Re: GCC Energy, LLC, King II Mine CDRMS Permit # C-1981-035 Stoner Engineering: Quarterly Inspection: Water Quality Improvements 3rd Quarter 2022

Re: King Coal I – Quarterly Water Quality Improvements Inspection

Pic. 1 – Sediment removal appears unchanged, West pond.

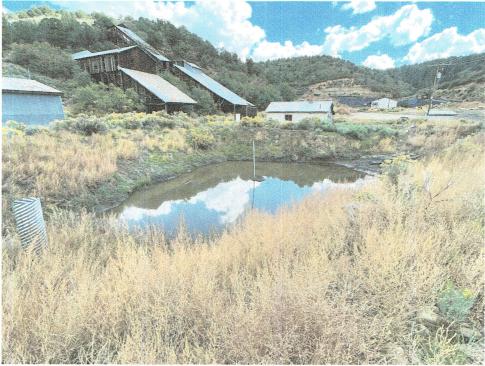
Both ponds held water at the time of the inspection due to recent storms. Additional sediment removal from the west pond does not appear to have taken place since the previous inspection (see Pic. 1). The east pond water level was at a level slightly higher that during the previous inspection (see Pic. 2). The ponds should continue to be monitored after storm events to ensure that excess sediment does not reduce the required storage capacity available for storm water runoff. When conditions permit, the removal of the excess sediment in the west pond should be completed.

Pic. 3 – South clear water ditch (Reach 3& 4) outlet at tie to north clear water ditch (Reach 5).

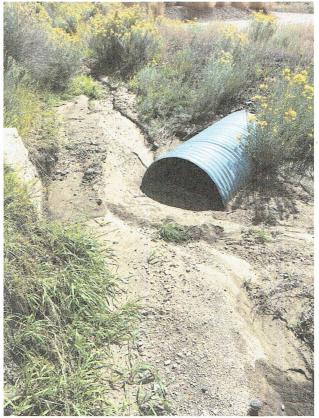
There has been sedimentation of the clear water ditch (Reach 5) at the outlet of the south clear water ditch (Reach 3 & 4) where it was rerouted to account for the construction of the lower waste embankment pile (see Pic. 3). This sediment should be cleared to prevent the culvert from backing up and/or reducing the capacity of the north clear water ditch. Reduced outflow of the culvert (Reach 3 & 4) could result in south clear water flows entering the west detention pond during a large storm event. All the culverts located on the site should be checked and any excess sediment cleared/cleaned after seasonal storm events.
